<b>Title - Sujet</b> Greenstone Building Fit-Up	
<b>Solicitation No. - N° de l'invitation</b> EW038-171054/A	<b>Amendment No. - N° modif.</b> 005
<b>Client Reference No. - N° de référence du client</b> DND EW038-171054	<b>Date</b> 2016-09-01
<b>GETS Reference No. - N° de référence de SEAG</b> PW-\$PWU-107-10836	
<b>File No. - N° de dossier</b> PWU-6-39120 (107)	<b>CCC No./N° CCC - FMS No./N° VME</b>
<b>Solicitation Closes - L'invitation prend fin</b> <b>at - à 02:00 PM</b> <b>on - le 2016-09-14</b>	<b>Time Zone</b> Fuseau horaire Mountain Daylight Saving Time MDT
<b>F.O.B. - F.A.B.</b> <b>Plant-Usine:</b> <input type="checkbox"/> <b>Destination:</b> <input checked="" type="checkbox"/> <b>Other-Autre:</b> <input type="checkbox"/>	
<b>Address Enquiries to: - Adresser toutes questions à:</b> Anthony, Mary	<b>Buyer Id - Id de l'acheteur</b> pwu107
<b>Telephone No. - N° de téléphone</b> (780) 237-7582 ( )	<b>FAX No. - N° de FAX</b> (780) 497-3510

**END OF ADDENDUM No. 02**

**PROJECT TITLE**  
**DND Office Fit Up - 3rd FLOOR**  
**YELLOWKNIFE, NWT**

**DWG NO.**  
**ASK 001**

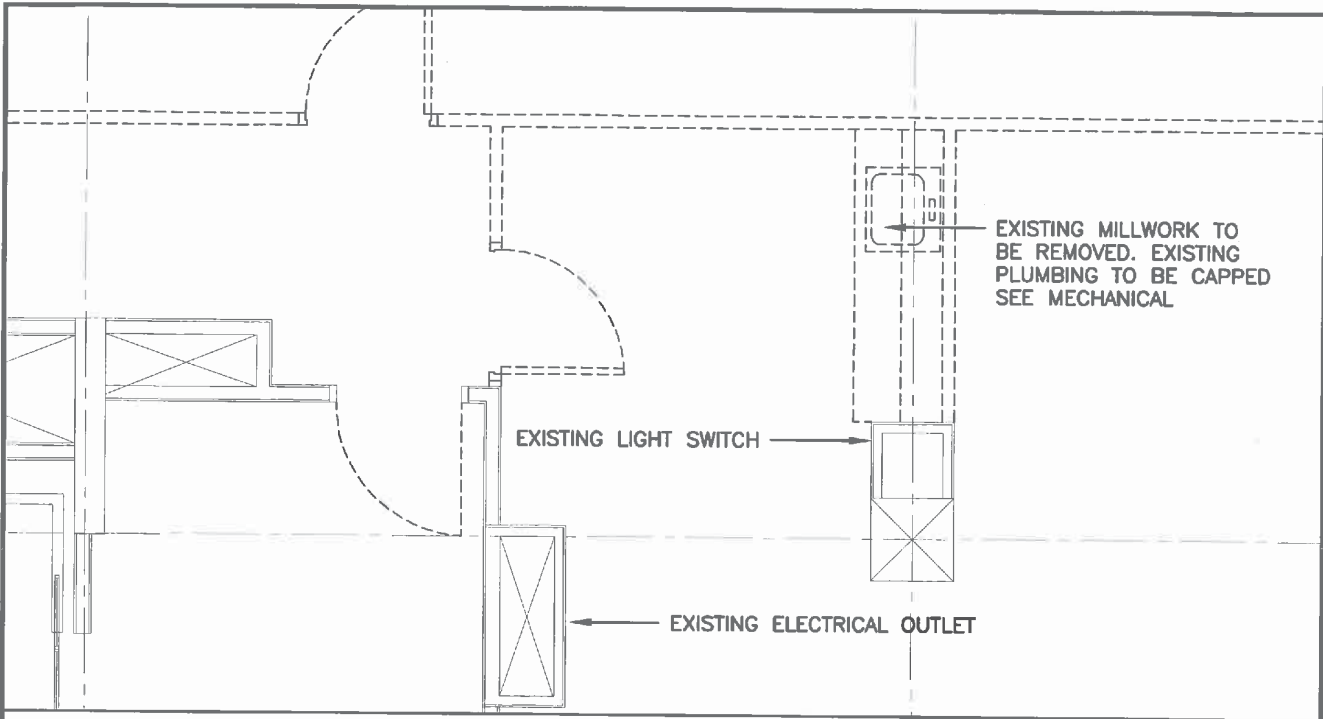
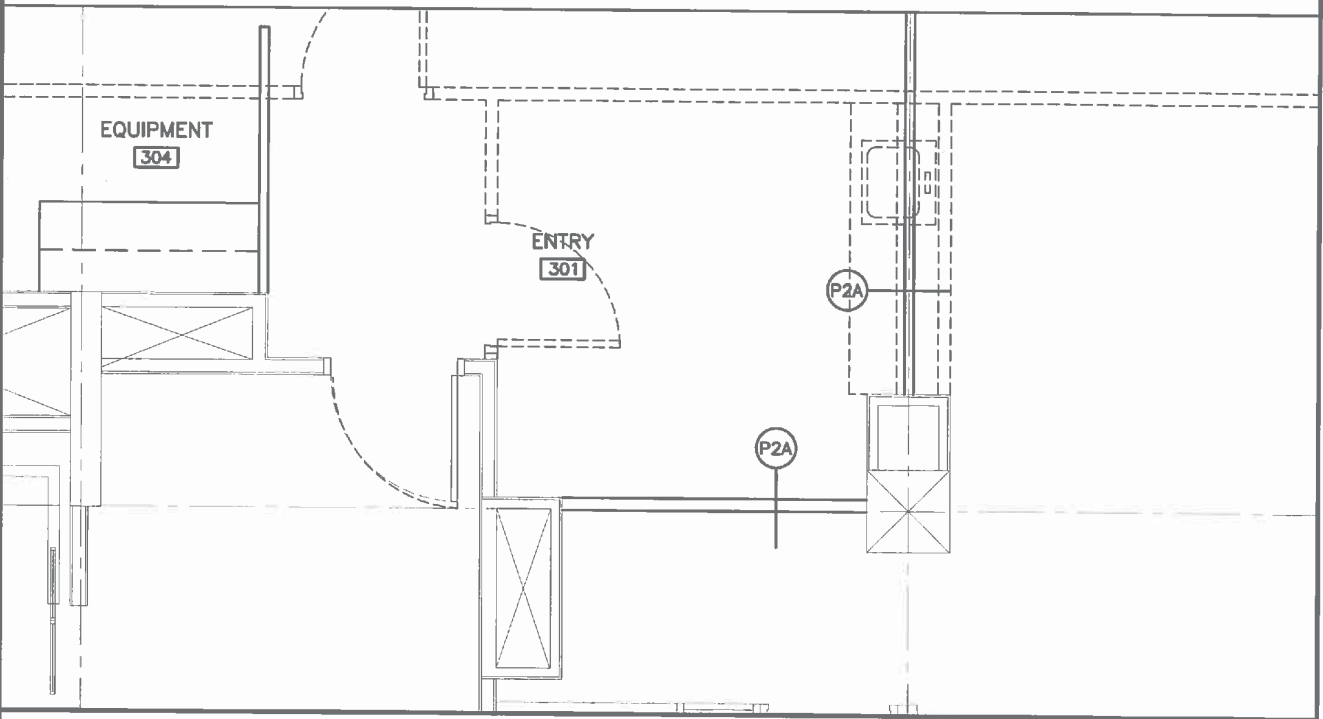
.4	Subject: Refer: Instructions:	Drawings Contract Documents - Sheet A03, 3 rd Floor Partial Floor Plan Revise Workstation Area 303 floor plan as indicated on ASK 01
.5	Subject: Refer: Instructions:.	Drawings Contract Documents - Sheet A036, P9A Security mesh may be fastened to existing partition.
<b>3.0</b>	<b>STRUCTURAL</b>	<b>NOT USED</b>
<b>3.0</b>	<b>MECHANICAL</b>	
.1	Subject: Refer: Instructions:	Mechanical Items. Contract Documents Refer to mechanical Addendum M-01
<b>4.0</b>	<b>ELECTRICAL</b>	
.1	Subject: Refer: Instructions:	Electrical Items. Contract Documents Refer to electrical Addendum E-01
